W3F1-2008-0052

SUBJECT: License Amendment Request NPF-38-277
License Amendment Request to Modify
Technical Specification Section 5.6, Fuel Storage and Add New Technical
Specification 3/4 9.12, Spent Fuel Pool Boron Concentration
Waterford Steam Electric Station, Unit 3
Docket No. 50-382
License No. NPF-38

Proposed Technical Specification Changes (mark-up)

Figure 5.6-1 Alternative Checkerboard Arrangements

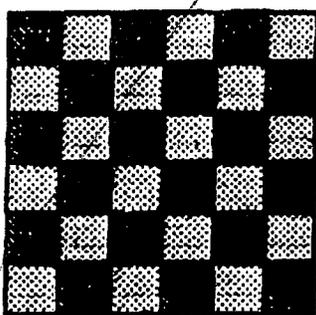
- g. TS Figure 5.6-1 will be replaced by a new Figure 5.6-1 to show the new Alternative Checkerboard Storage Arrangements.
- h. TS Figure 5.6-2 will be replaced by a new Figure 5.6-2 to show the new Acceptable Burnup Domain for Unrestricted Storage of Irradiated Fuel in Region 2 of the Spent Fuel Pool.

REPLACE WITH INSERT 1

Note: Either of these checkerboard arrangements may be used in areas contiguous to areas of unrestricted storage in Region 2. For interfaces between a fresh fuel checkerboard and an irradiated fuel checkerboard, each high-reactivity irradiated assembly (e.g., 27 GWd/MTU) may be face-adjacent to no more than one fresh fuel assembly; each fresh fuel assembly may be face-adjacent with up to two high-reactivity irradiated fuel assemblies. See Figure 5.6-4 for examples of contiguous fresh fuel checkerboards and irradiated fuel checkerboards which meet these requirements.

Figure 5.6-1 Alternative Checkerboard Storage Arrangements

Figure 5.6-2 Acceptable Burnup Domain for Unrestricted Storage of Irradiated Fuel in Region 2 of the Spent Fuel Pool

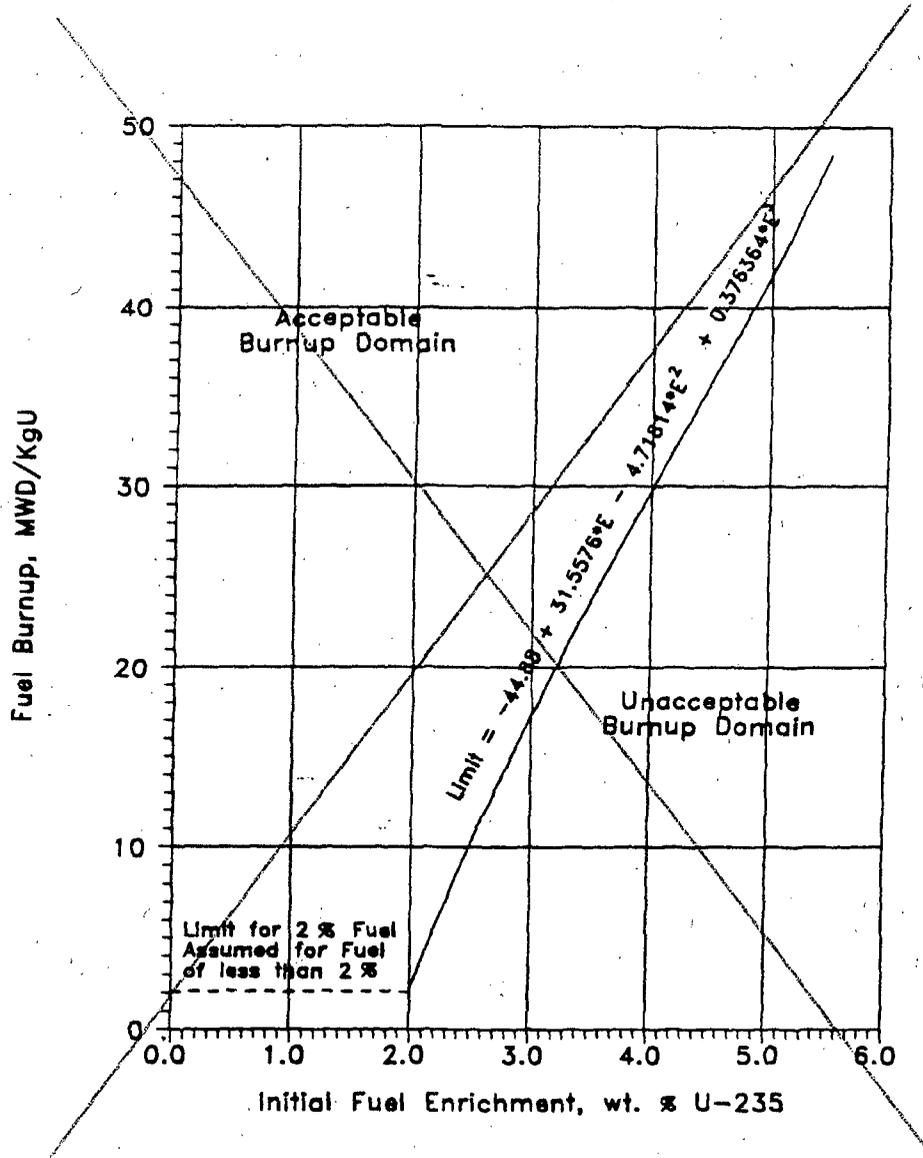
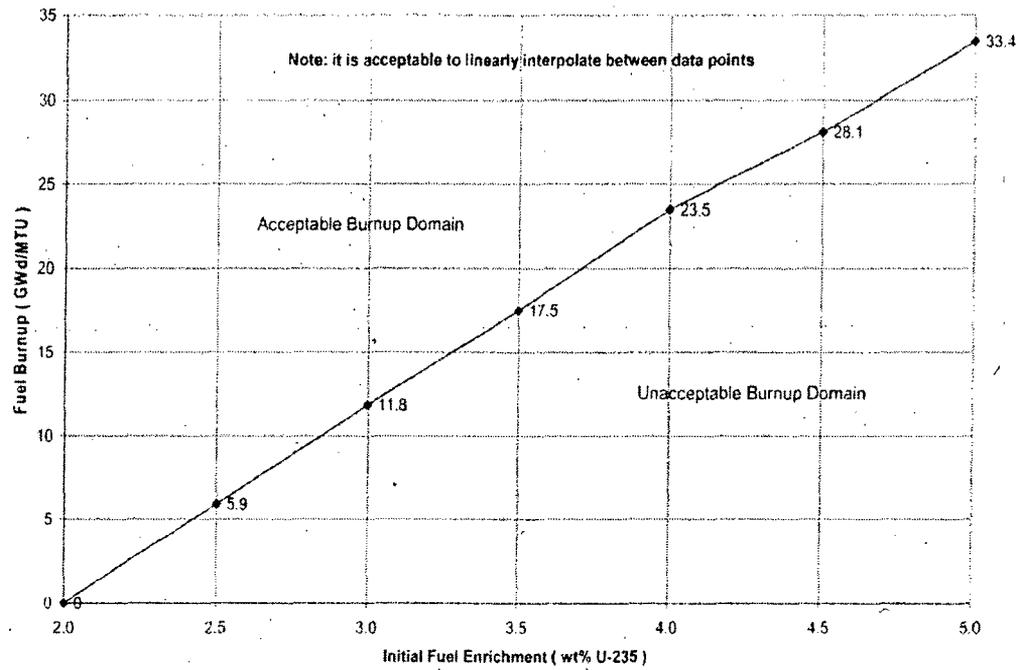
REPLACE WITH INSERT 2

Figure 5.6-3 Acceptable Burnup Domain for Irradiated Fuel in a Checkerboard Arrangement with Fuel of 5 wt% Enrichment, or Less, at 27 GWd/MTU Burnup, or Higher, in Region 2 of the Spent Fuel Pool

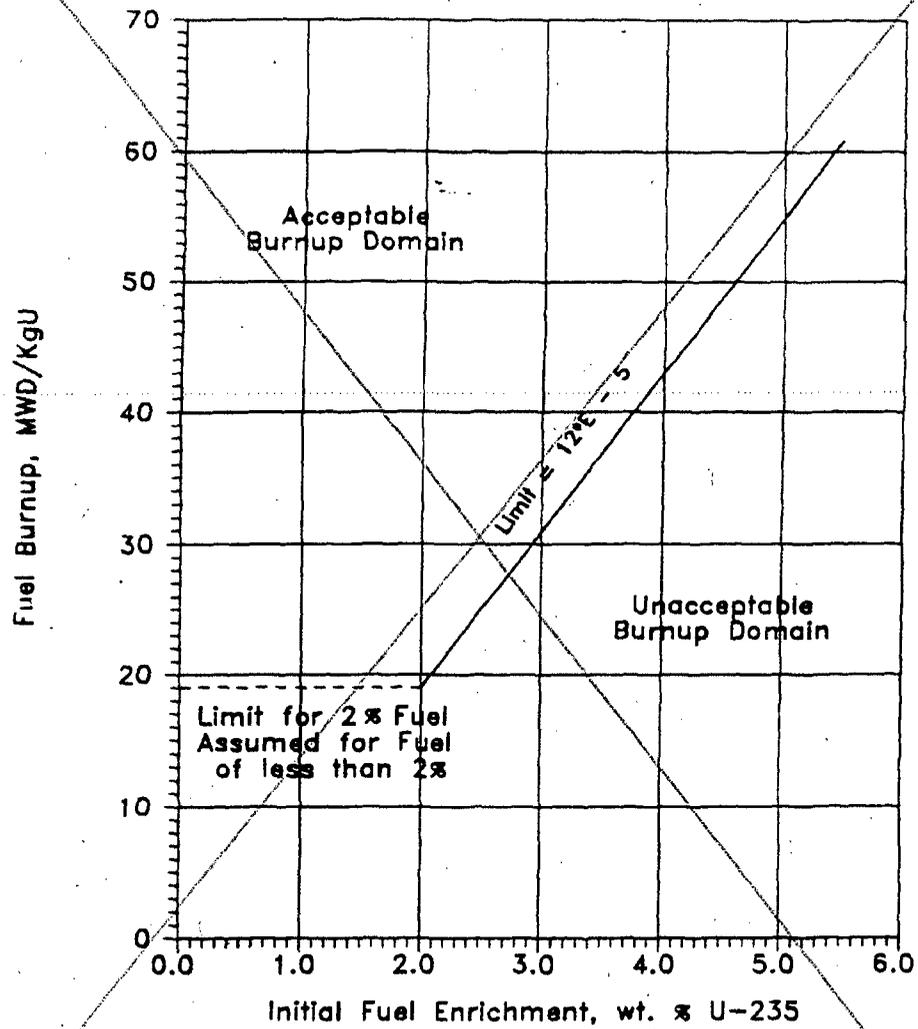
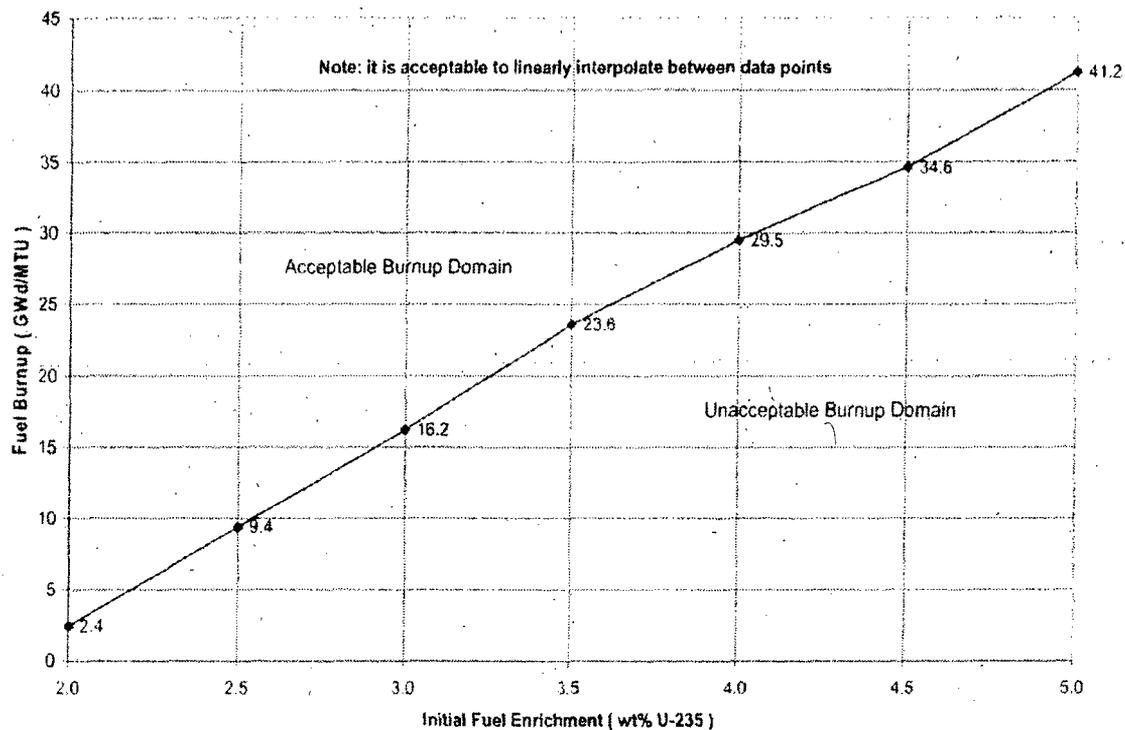
- i. TS Figure 5.6-3 will be replaced by a new Figure 5.6-3 to show the Acceptable Burnup Domain for Irradiated Fuel in a Checkerboard Arrangement with Fuel of 5 wt % Enrichment, or less, at 27 GWd/MTU Burnup, or higher, in Region 2 of the Spent Fuel Pool.

REPLACE WITH INSERTS 3 AND 4

Figure 5.6-4 Examples of Contiguous Fresh Fuel and Irradiated Fuel Checkerboards Which Meet Interface Requirements

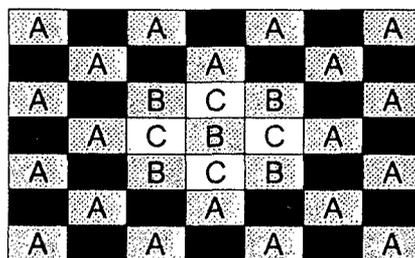
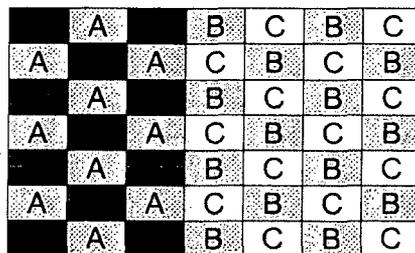
- j. A new TS Figure, TS Figure 5.6-4, will be added to show Examples of Contiguous Fresh and Irradiated Fuel Checkerboards Which Meet Interface Requirements.
